## Rezoning Transportation Analysis

<b>Petition Number</b>	2016-061	<b>Updated</b>	3/28/2016
<b>Location</b>	Approximately 26.56 acres located on the northeast corner at the intersection of Wilora Lake Road and Venedale Road.		
<b>Staff Resource</b>	Kory Hedrick	<a href="mailto:khedrick@charlottenc.gov">khedrick@charlottenc.gov</a>	704.432.6511

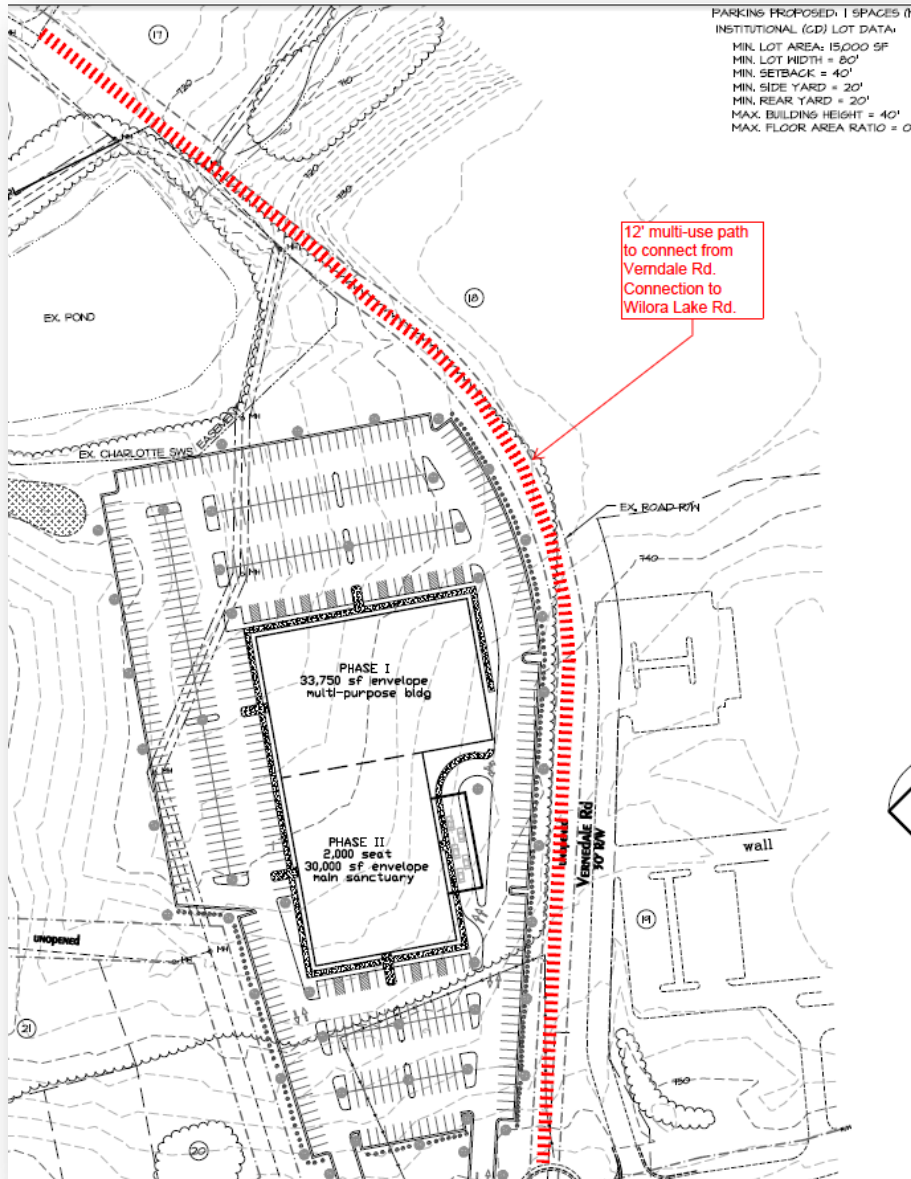
1. CDOT requests that the petitioner install a 12' multi-use path in the existing right of way for Verndale Rd. This connection would be similar to as shown below:
